RIVERSTONE SOUTH SIXTH ADDITION
 Ramsey, MN

EXISTING CONDITIONS

2 Xcon.pdf V2 - Changemark Notes (1 Note)

3 Preplat.pdf V2 - Changemark Notes (4 Notes)

4 Site.pdf V2 - Changemark Notes (3 Notes)

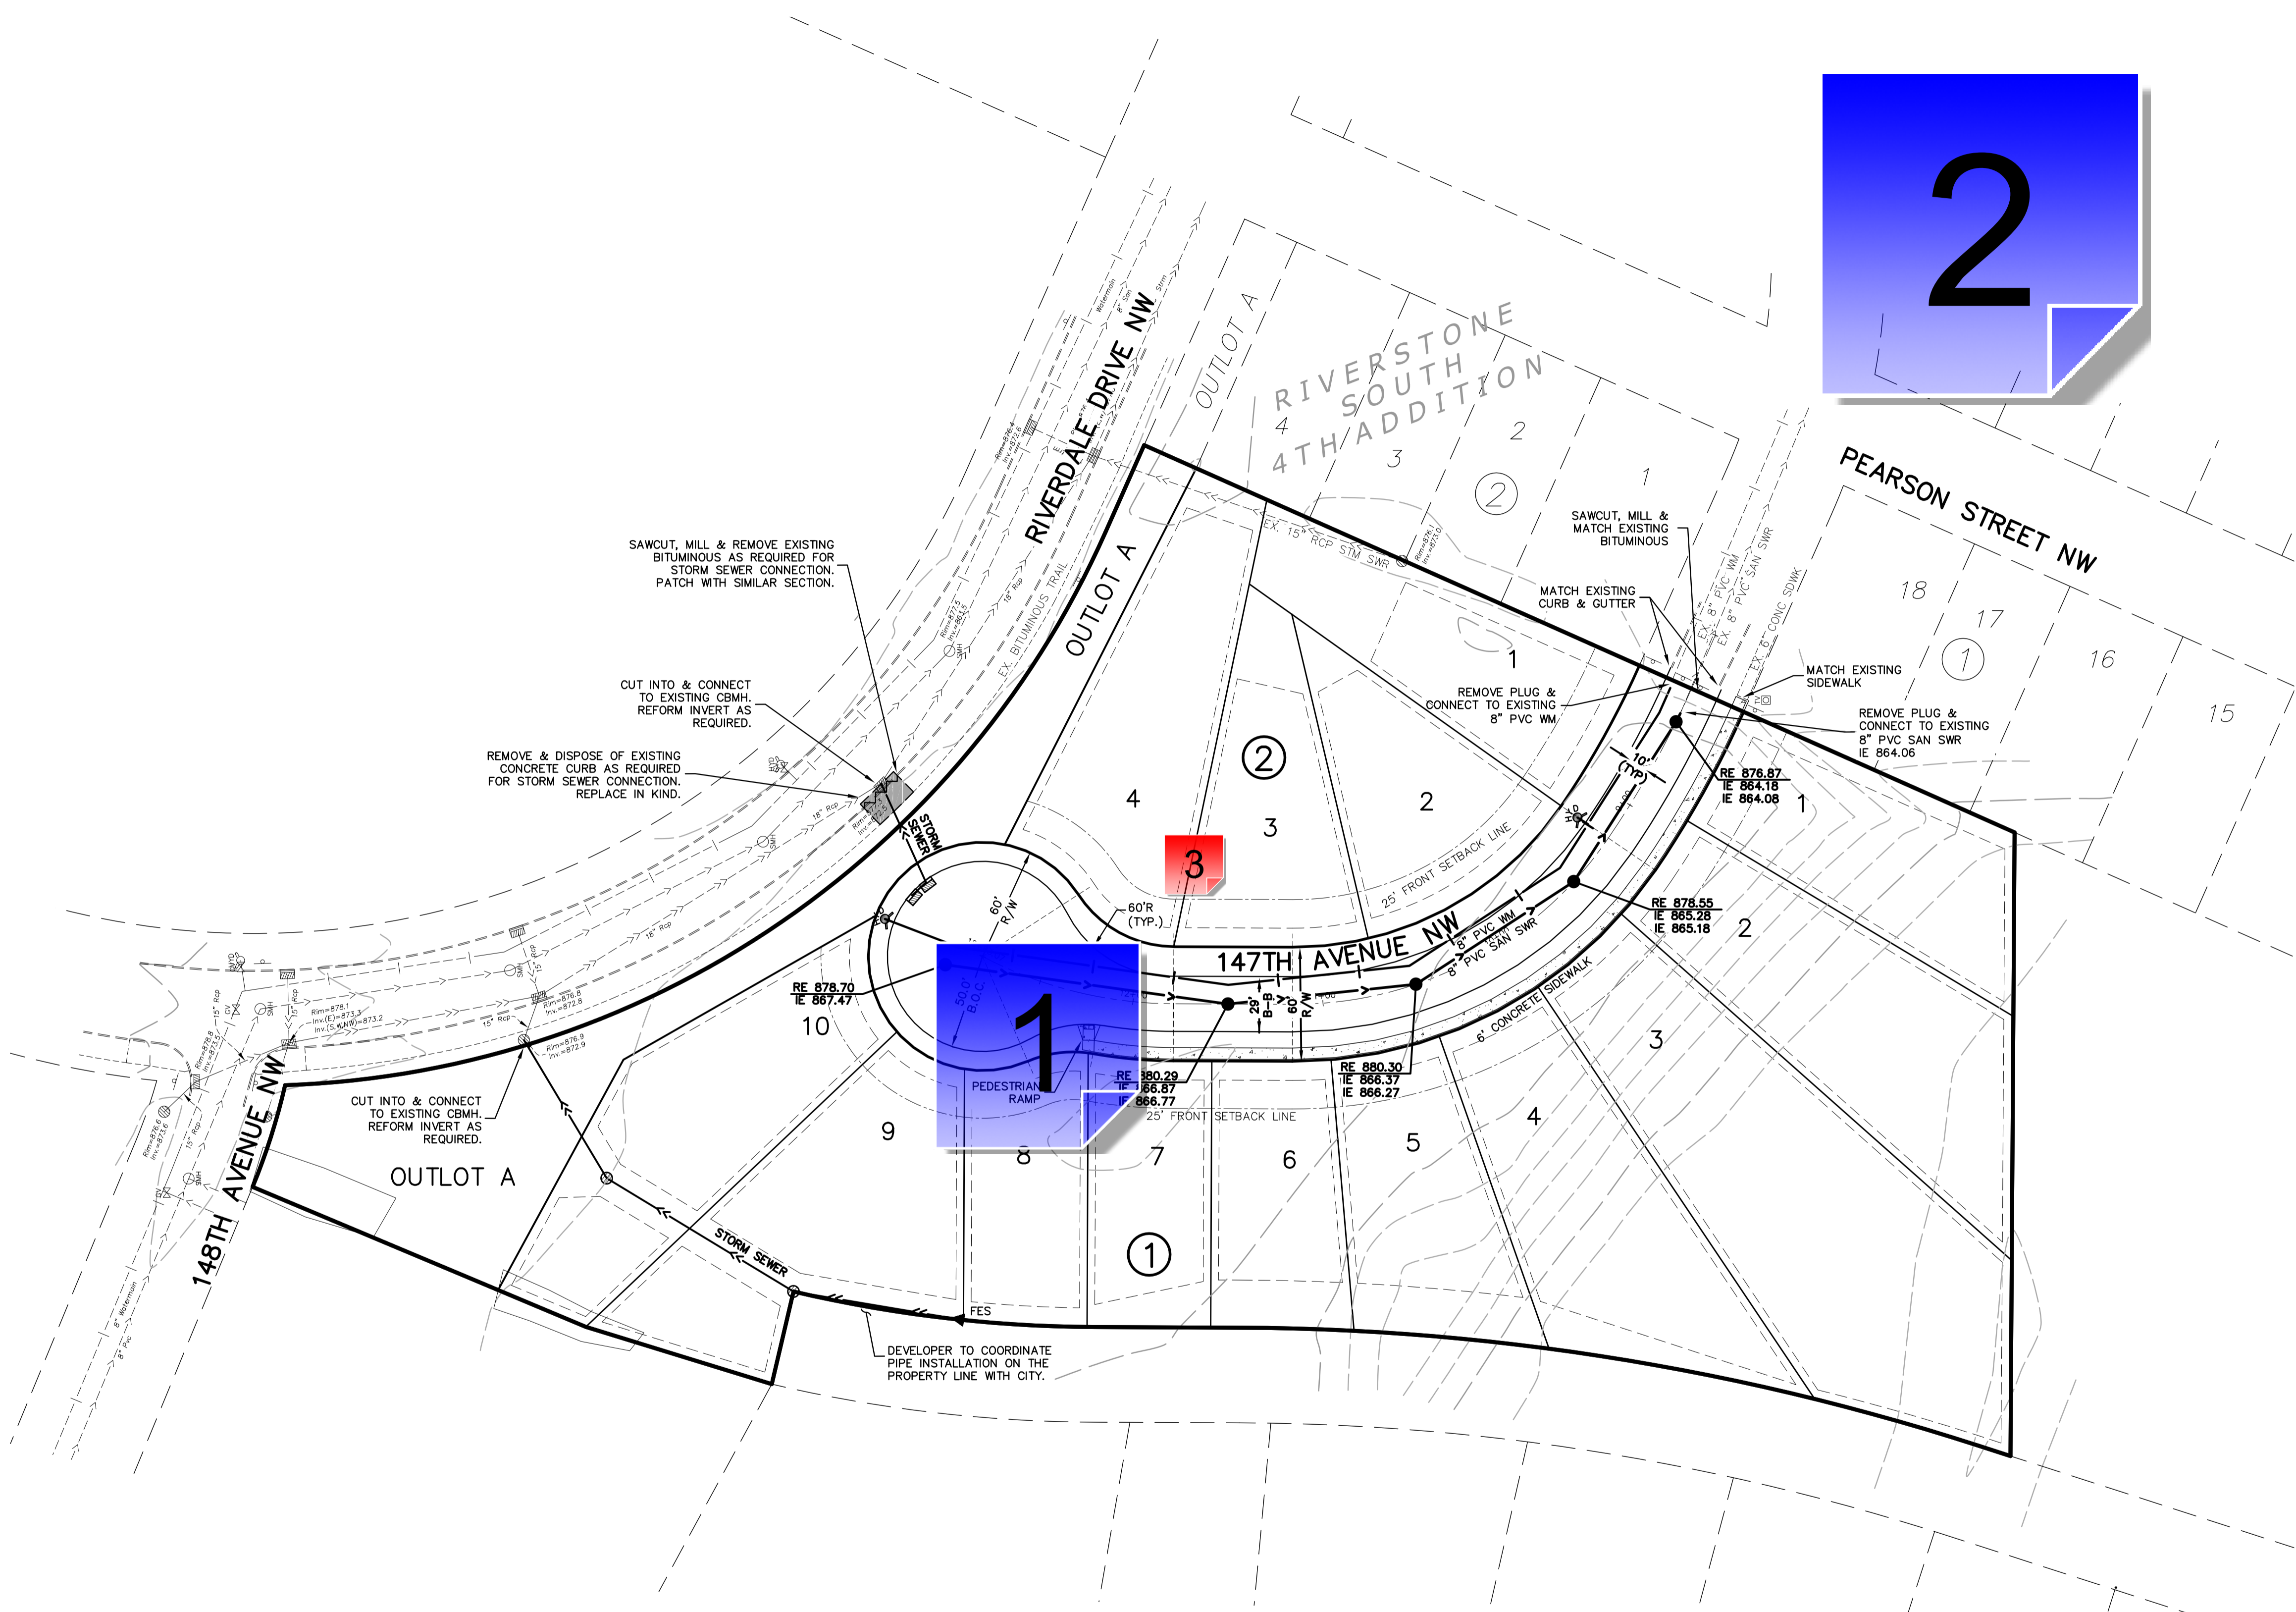
1 - Street Light

Please add a street light somewhere in the vicinity of the ped ramp. This should be a 25' tall Low Profile LED light.

2 - cul de sac length

Cul-de-sac length, measured from the intersection of origin to the end of ROW, is limited to 600 feet. While the length of the street within RSS6 is only about 512 feet, the measurement needs to extend back to the intersection of 147th and Pearson Street. That total length measures about 640 feet. This will require a variance. Staff would support the variance because we do not want to see this road connected with Riverdale Drive.

3 - Public Utilities

For final plat please provide profile views for sewer & water as well as relevant details.
